Project	IEEE 802.16 Broadband Wireless Access Working Group < http://ieee802.org/16 >
Title	CR on SDD Section 18: Procedure of Interference Mitigation among multiple cells
Date Submitted	2009-2-24
Source(s)	Honghai Zhang, Linghang Fan, Sampath Rangarajan, Nader Zein, Tetsu Ikeda, Andreas Maeder, Amir Khojastepour, Mohammad Madihian honghai@nec-labs.com NEC
Re:	Change request to Project 802.16m System Description Document (SDD) (IEEE 802.16m-08/003r7)
Abstract	This contribution provides text addition to SDD to facilitate the interference mitigation among multiple cells in SON .
Purpose	For discussion and approval by IEEE 802.16m TG
Notice	<i>This document does not represent the agreed views of the IEEE 802.16 Working Group or any of its subgroups. It represents only the views of the participants listed in the "Source(s)" field above. It is offered as a basis for discussion. It is not binding on the contributor(s), who reserve(s) the right to add, amend or withdraw material contained herein.</i>

Procedure of Interference Mitigation among multiple cells

Figure 1 Procedure of Interference Mitigation

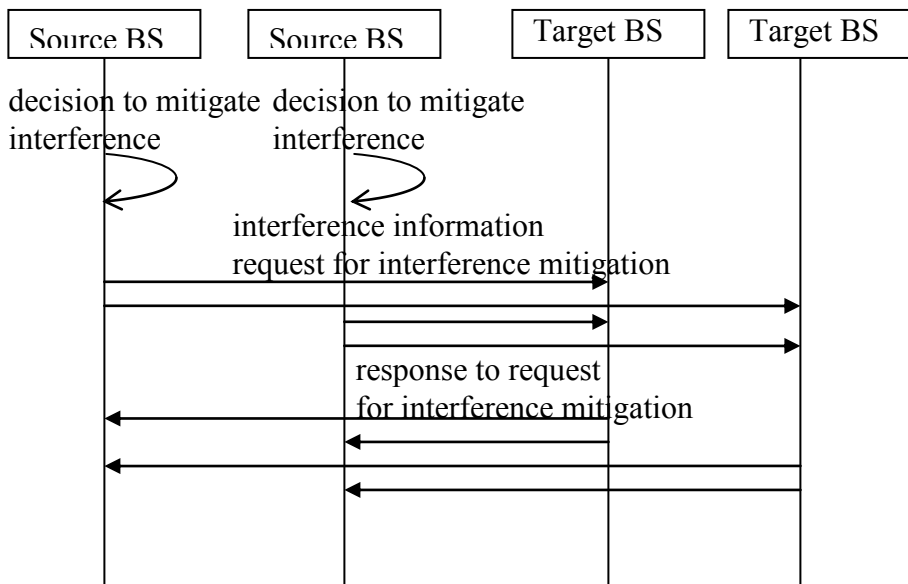
Insert the following text into the “Support for Self-organization” clause (IEEE 802.16m-08/003r7):

18.2.2 Interference Management and Optimization

Source BSs can continuously monitor its own interference situation, decide to mitigate interference, and then collect interference information and related parameters from the MSs and the neighbor cells. Then the source BS decides which neighbor BSs are the target BSs which need to control its transmission power and sends them the power update request or necessary information to compute appropriate transmission power for interference mitigation. Each target BS receives the requests, analyzes its own interference situation, and decides whether to change its power settings, and sends back the response to the source BSs. After receiving the response or not receiving the response after a pre-specified period, Source BS can continue to send interference mitigation request or cease interference mitigation.
